Stability Pathfinder Phase 2 RFI FAQ

Updated 05/10/20

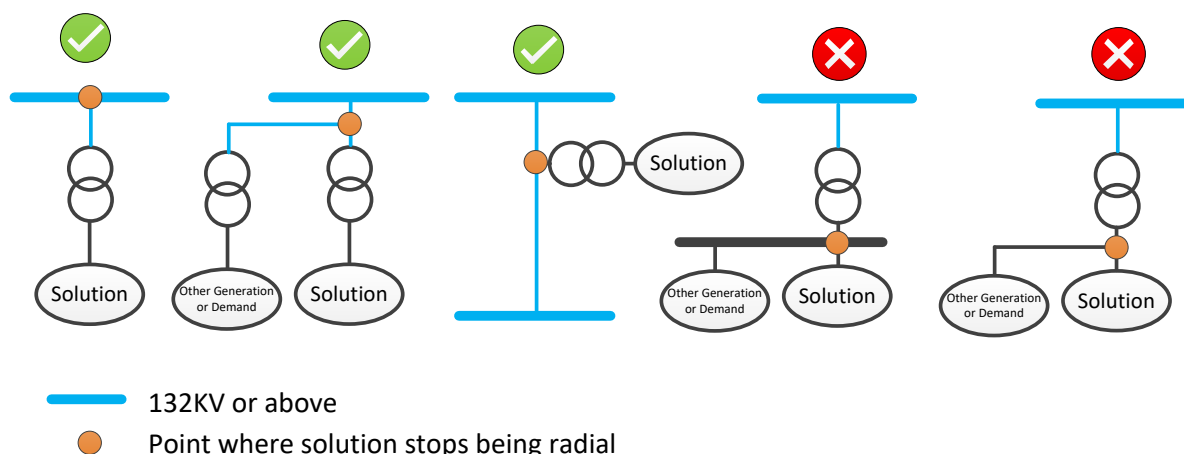
18. Which year between now and 2030 is your network model based on? (updated 03/07/20)

Our network models take a view of expected future network upgrades.
